REVISIONS		BY	DATE
△1	ADDITIONAL WINGWALL HT.	BSB	08/01/2014

END BENT 1 DETAILS
JIMMY DELOACH CONNECTOR
OVER GRANGE ROAD
CHATHAM COUNTY CSMSL-0008-00(690)

DRAWING NO. 35-07
BRIDGE SHEET 7 OF 9

BENT 2 - WINGWALL DETAIL △1
SCALE: NONE
LEFT SIDE WINGWALL

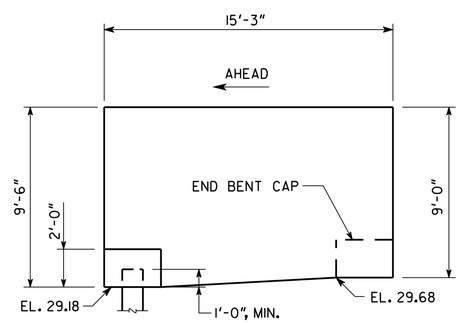
1. MAINTAIN 2" CLEARANCE ON ALL REINFORCEMENT UNLESS OTHERWISE NOTED.
2. POUR WINGWALLS MONOLITHICALLY WITH THE CAP.
3. SEE GEORGIA STANDARD 9037 FOR DRAINAGE DETAILS AT END BENT.
4. WINGWALL PILES NOT SHOWN IN ELEVATION.
5. △1 BOTTOM OF BENT 2, LEFT WINGWALL IS SLOPED, SEE DETAIL. BOTTOM OF ALL OTHER WINGWALLS ARE LEVEL.
